Public Works Department – Engineering Division

ADDENDUM NO. 3

PROJECT 5067 WTP FILTER IMPROVEMENTS AND HYPOCHLORITE CONVERSION

DWG. NO.
C106

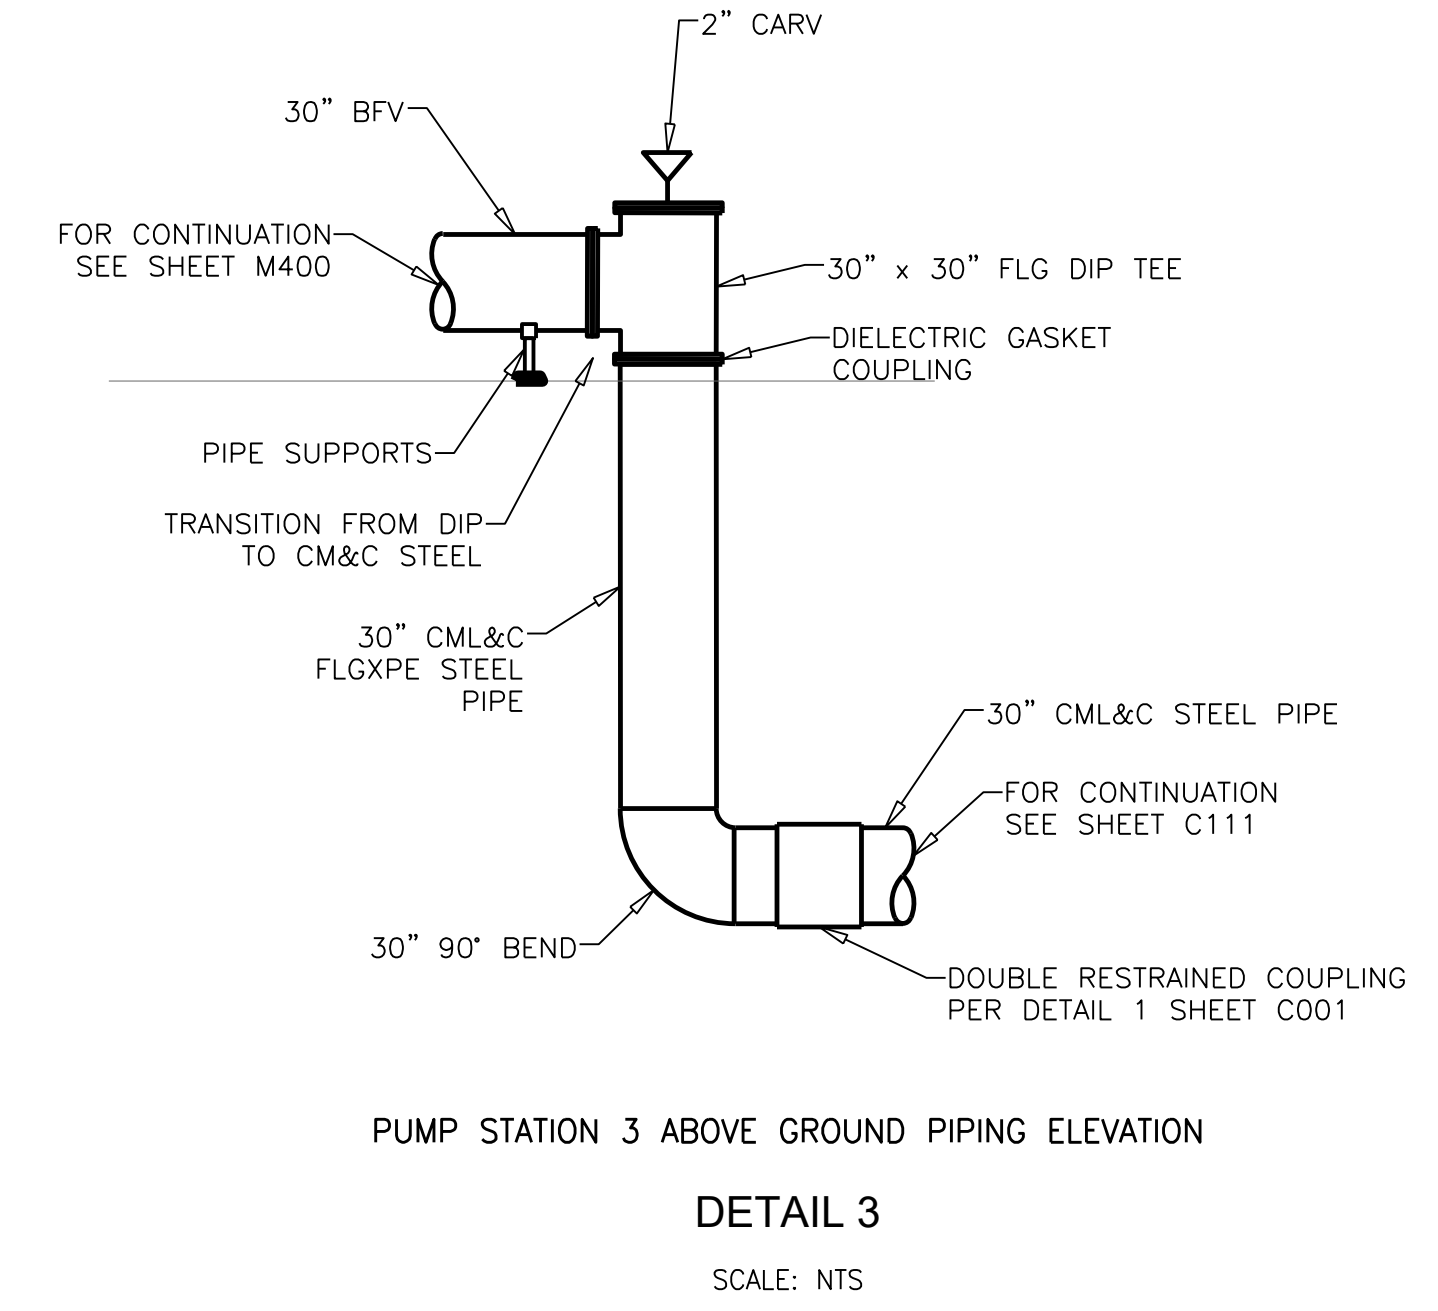
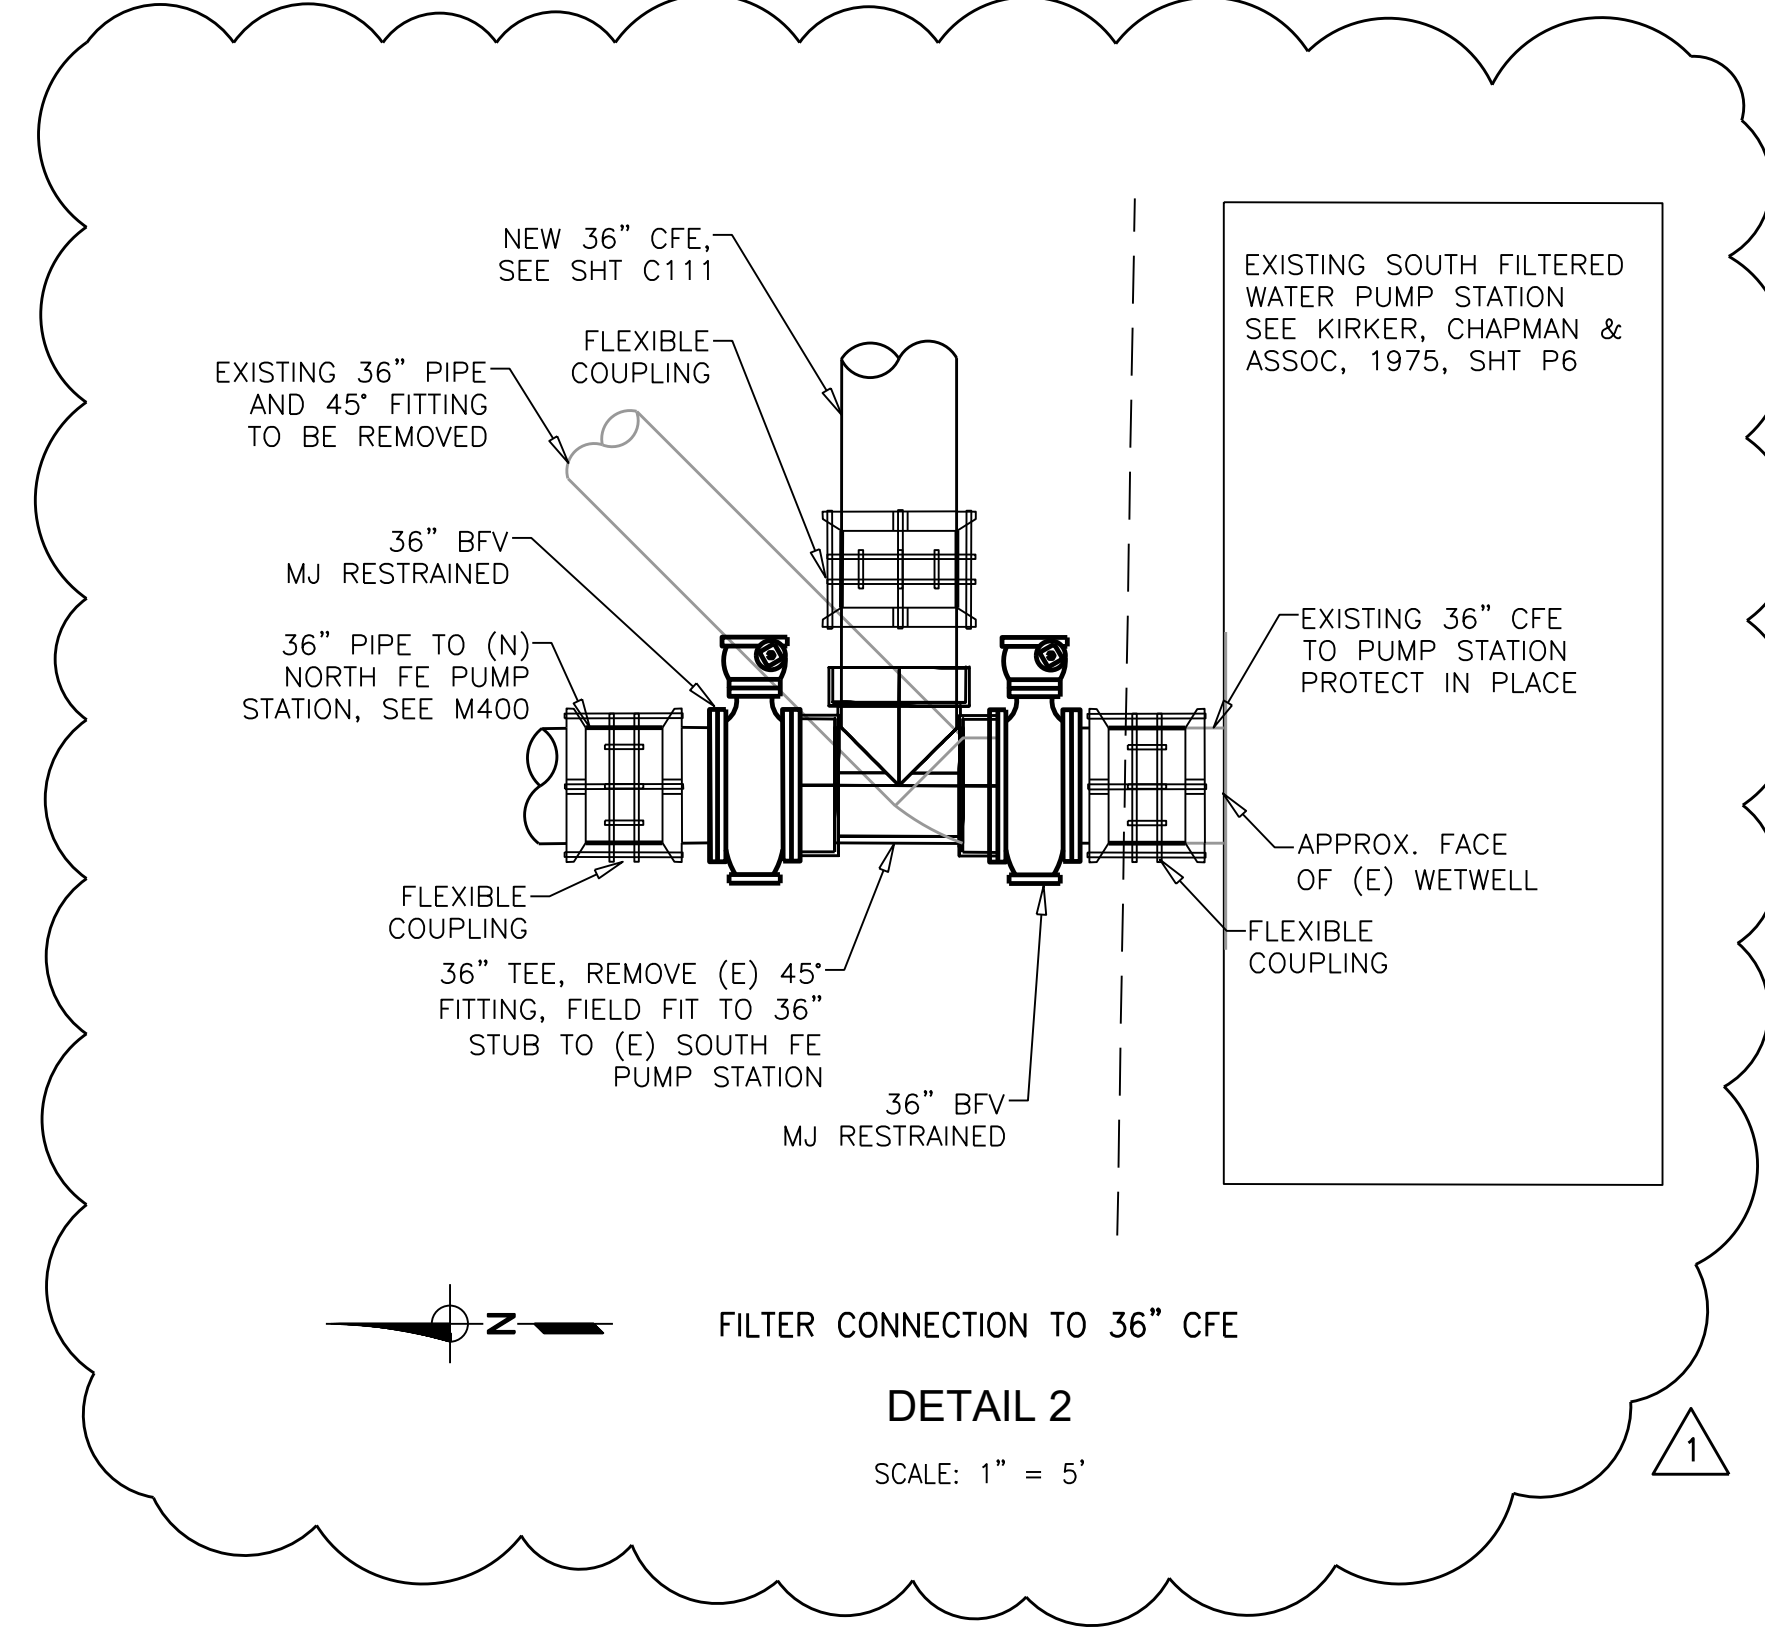
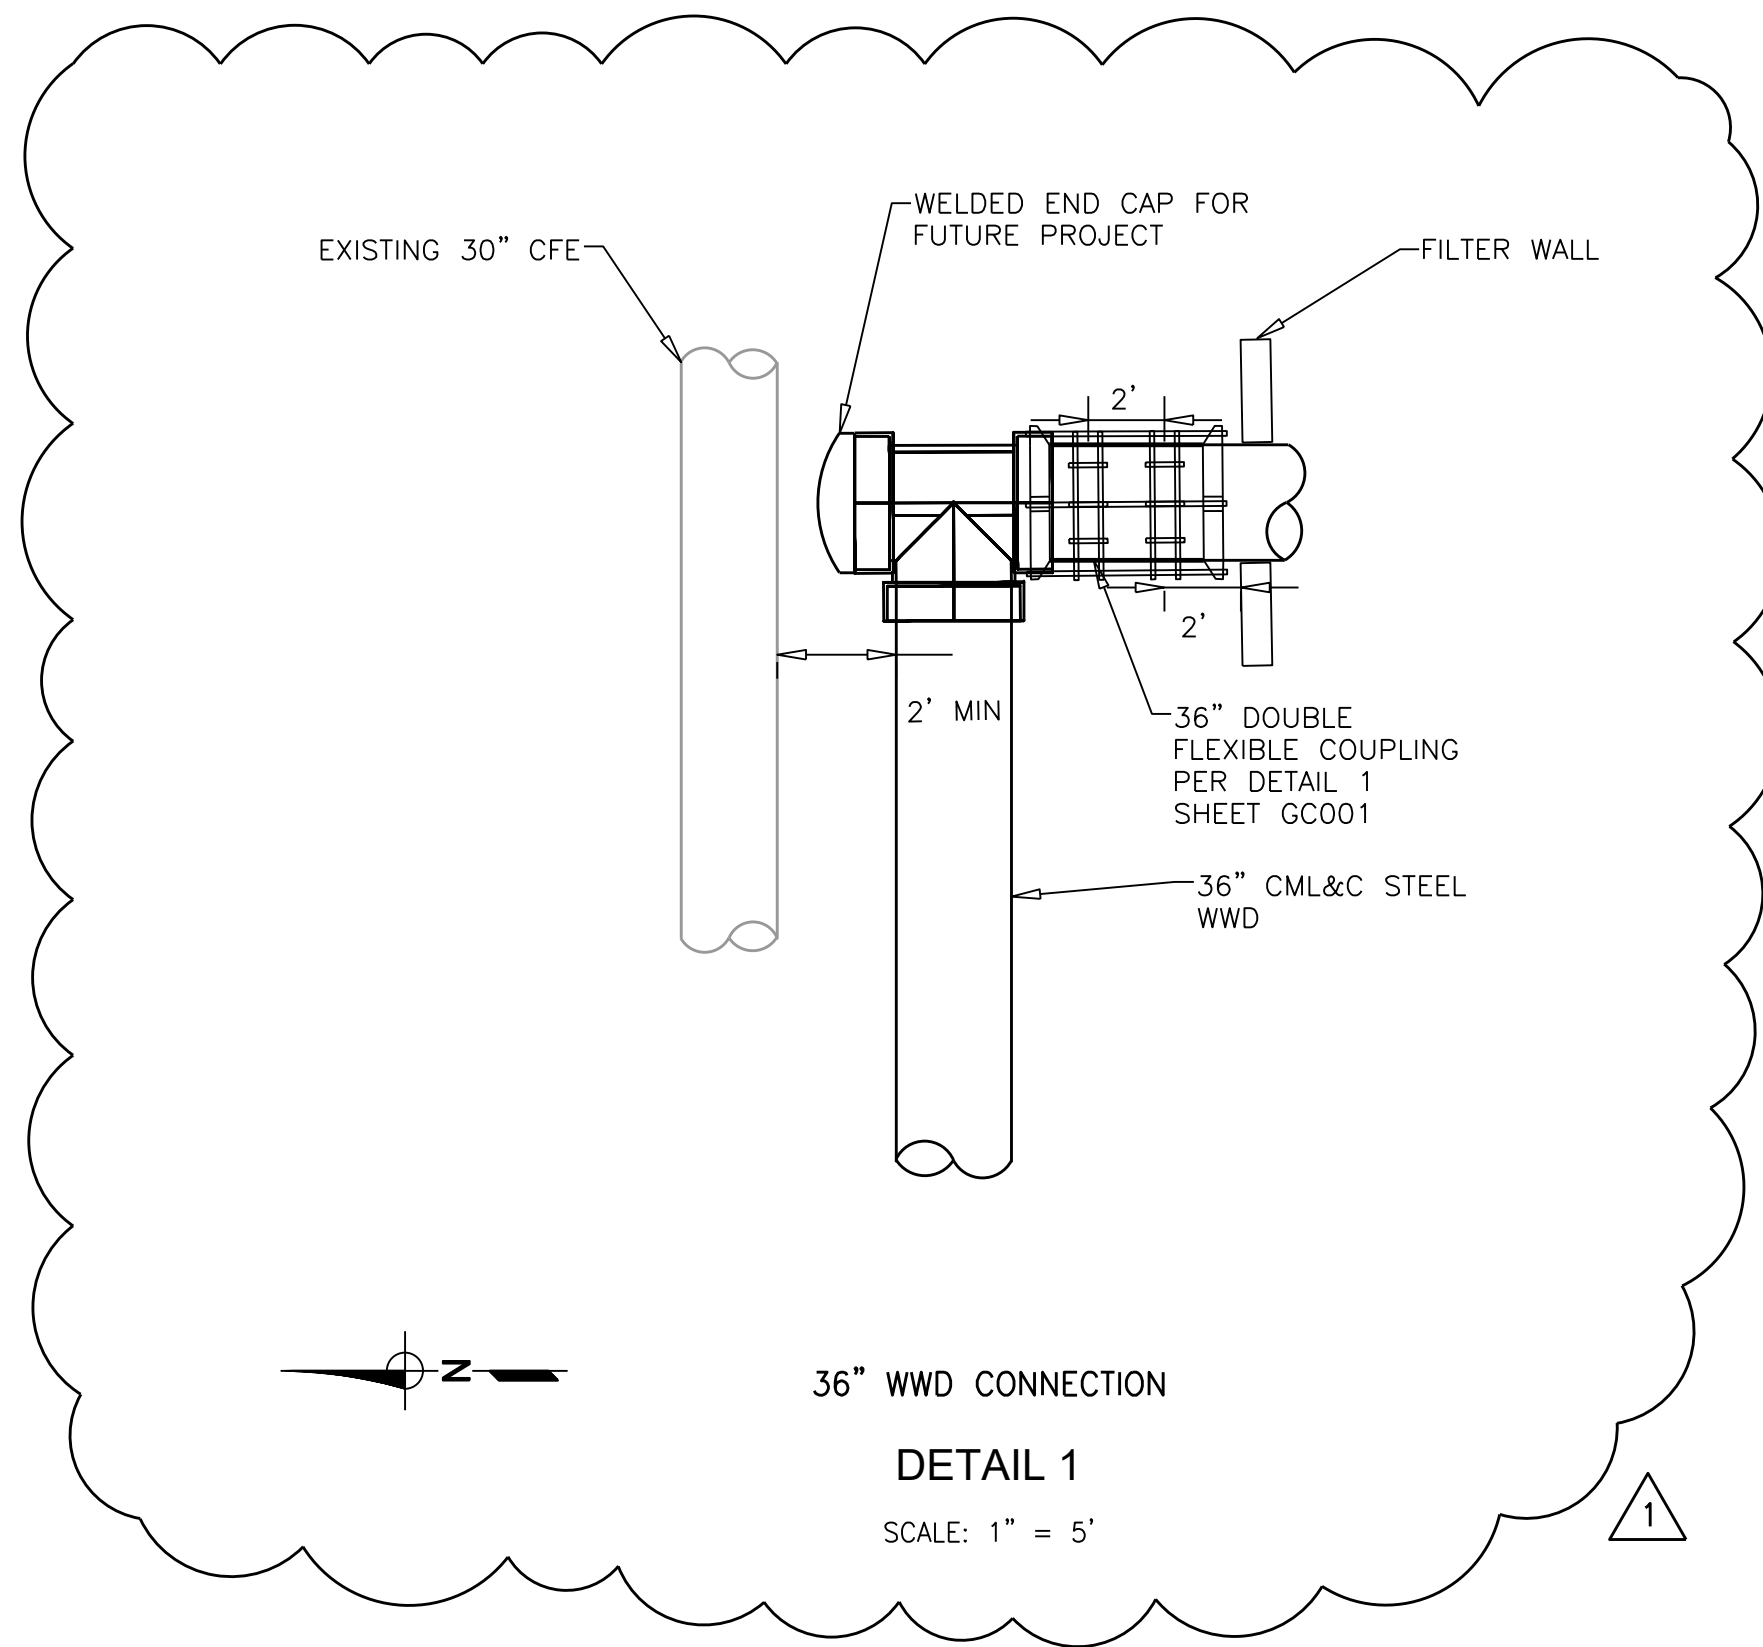
33. On Drawing C106, in the "Proposed Pipe Column" in the pipe connection table, replace "PVC" designations with "PVC-S".
